**Re: Adding a Fence around Burma Pond (C/015/032) (13-006)**

Included you will find a revision to Page 11 of Appendix 7-66 and revised maps.

| Title of Proposal: <b>Adding a fence to Burma Pond (13-006)</b> |                                     |                                  |                                   |                                      |                                       | Mine: <b>GENWAL Mine</b>                 |

**DRAWING 4**  
**EVAPORATION BASIN**  
**PLAN VIEW**

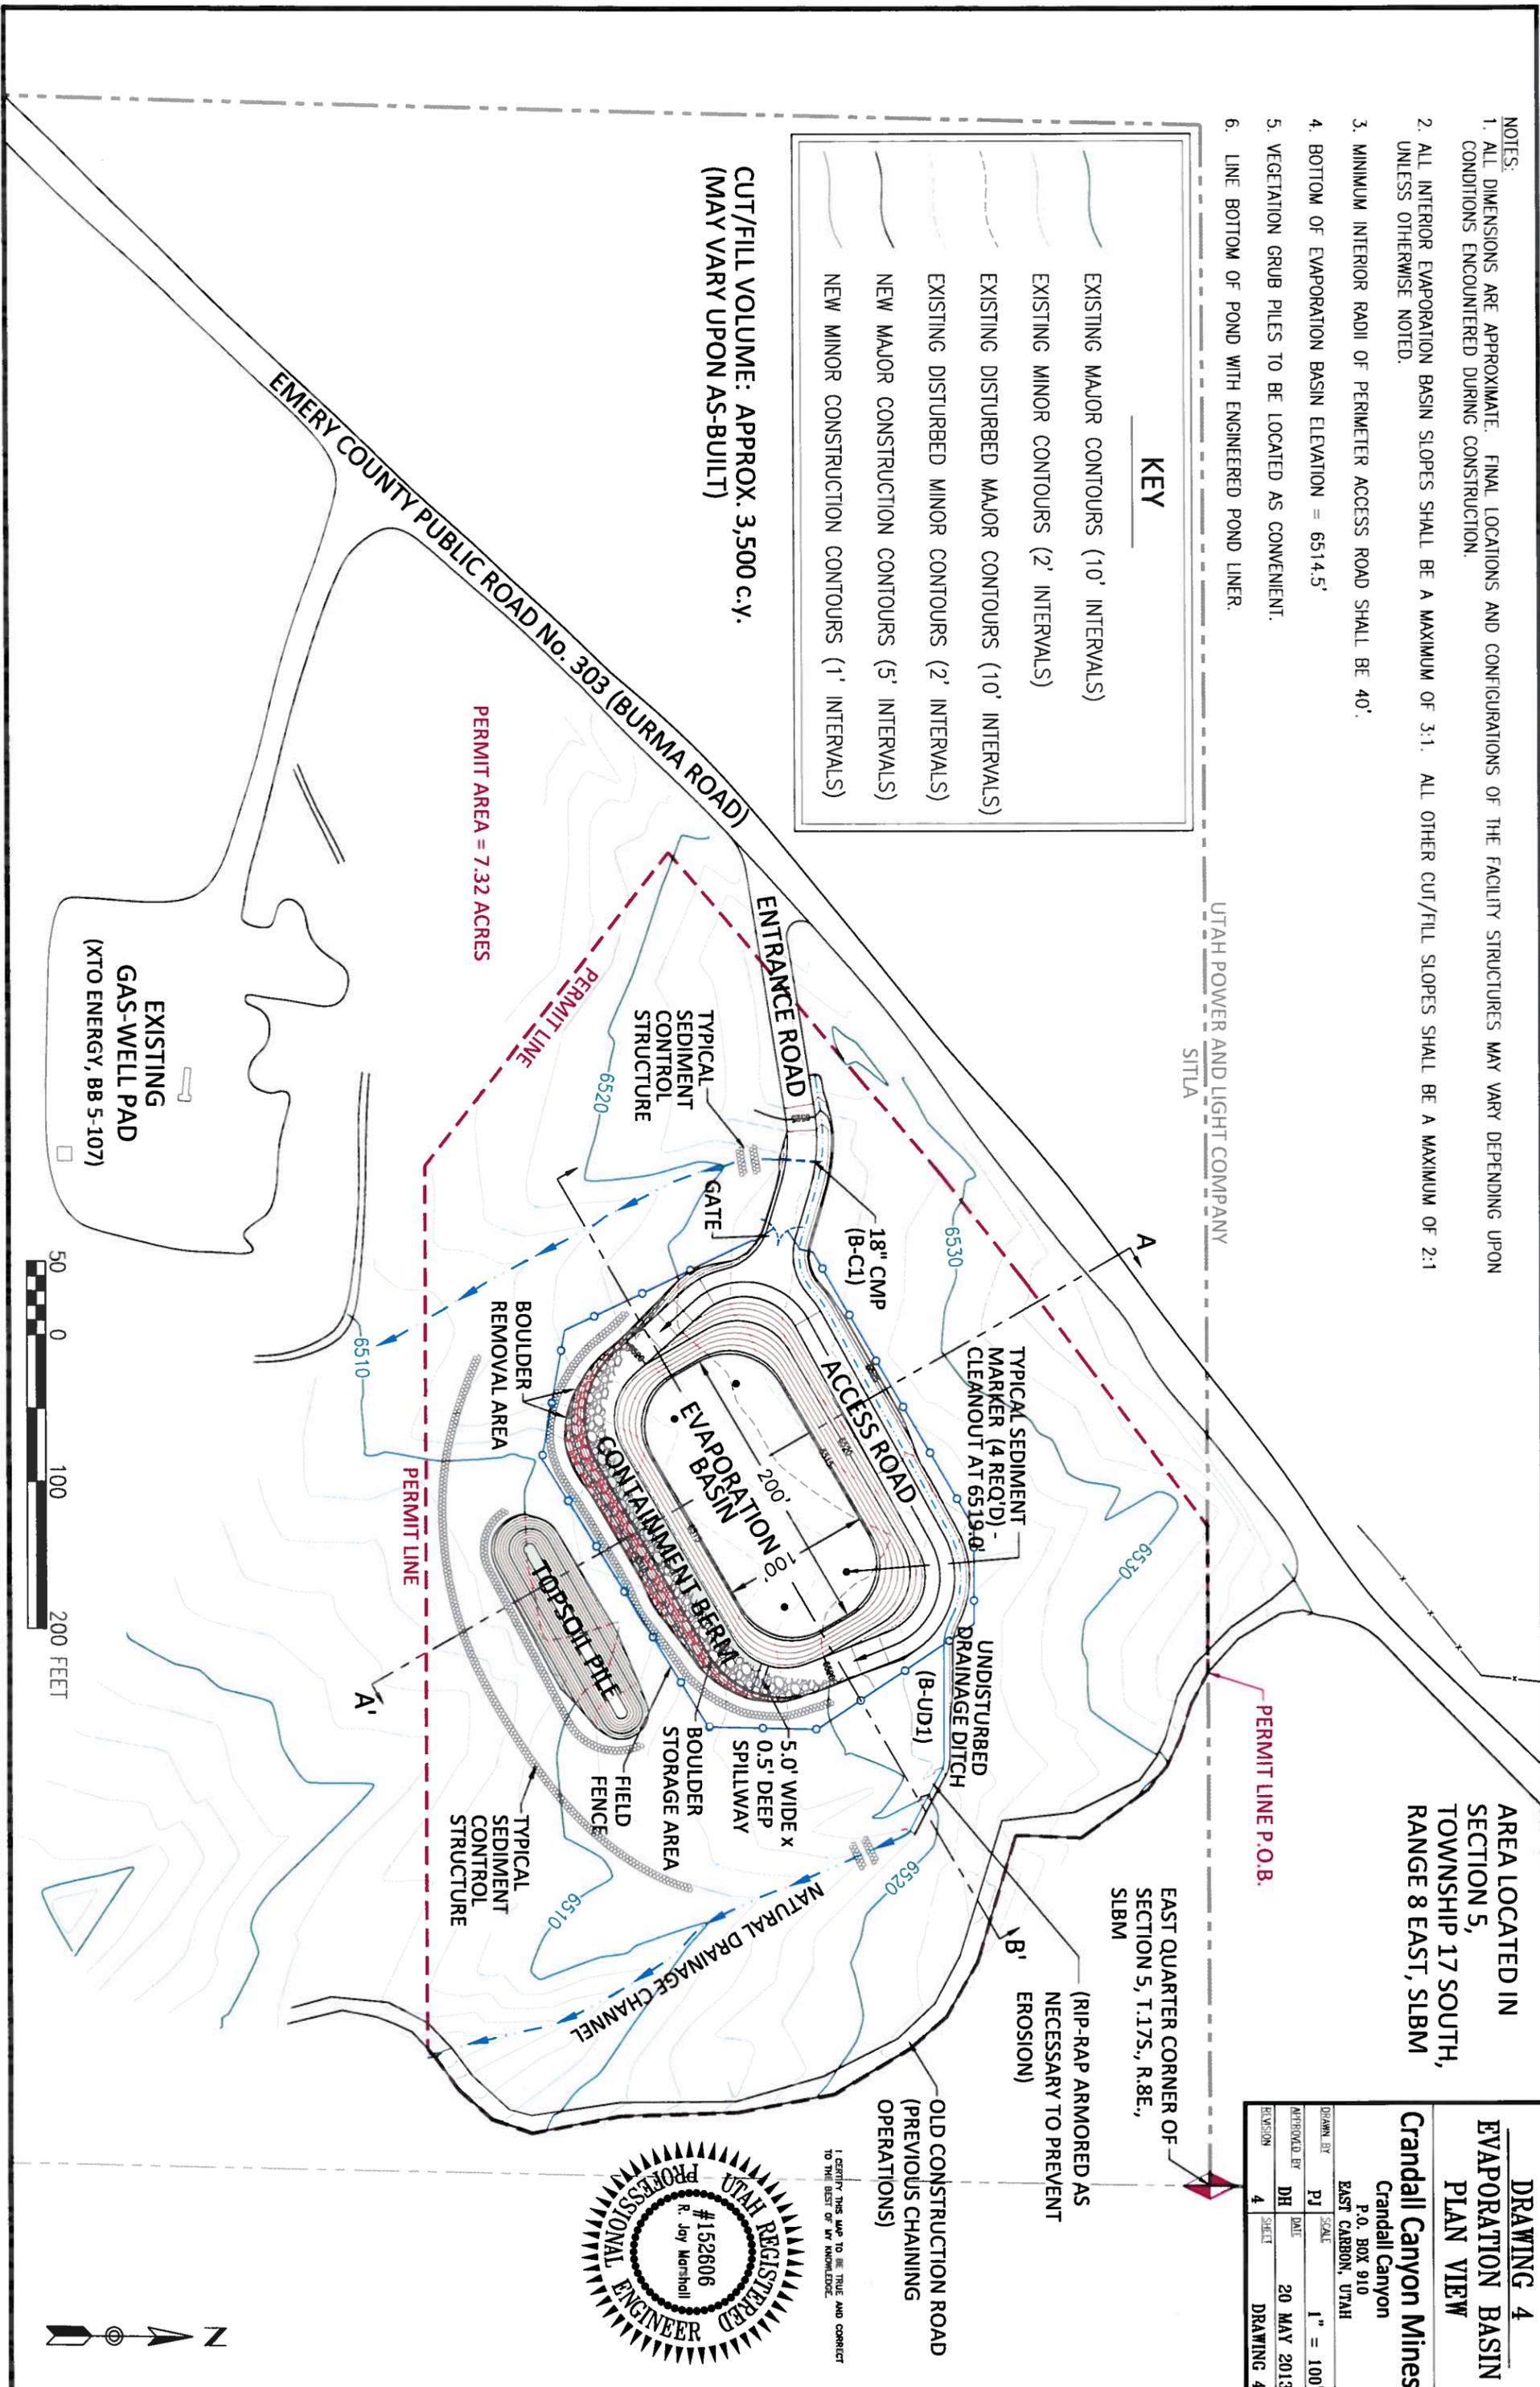
As you are aware the Burma Pond is complete. However, accidental access is possible from the County Road. To prevent this accidental access and to prevent cattle and wildlife from puncturing the pond liner, UEI proposes to construct a fence around Burma Pond.

13) The in-slopes to the basin will be constructed to a shallow slope of 3 vertical to 1 horizontal. ~~With these gentle in-slopes, and the shallow depth of containment, there will be no necessity for any perimeter barricade or fence for wildlife protection, or public safety. Also, as mentioned previously,~~ **Even though** the basin contents (dried iron precipitate material) has been tested as non-toxic, non-hazardous and non-acid forming, **posing and poses** no public health threat, **a fence and gate will be installed around the pond to protect the pond liner from cattle and wildlife. The gate will prevent accidental and unauthorized access from the road.**

13) The in-slopes to the basin will be constructed to a shallow slope of 3 vertical to 1 horizontal. Even though the basin contents (dried iron precipitate material) has been tested as non-toxic, non-hazardous and non-acid forming, and poses no public health threat, a fence and gate will be installed around the pond to protect the pond liner from cattle and wildlife. The gate will prevent accidental and unauthorized access from the road.
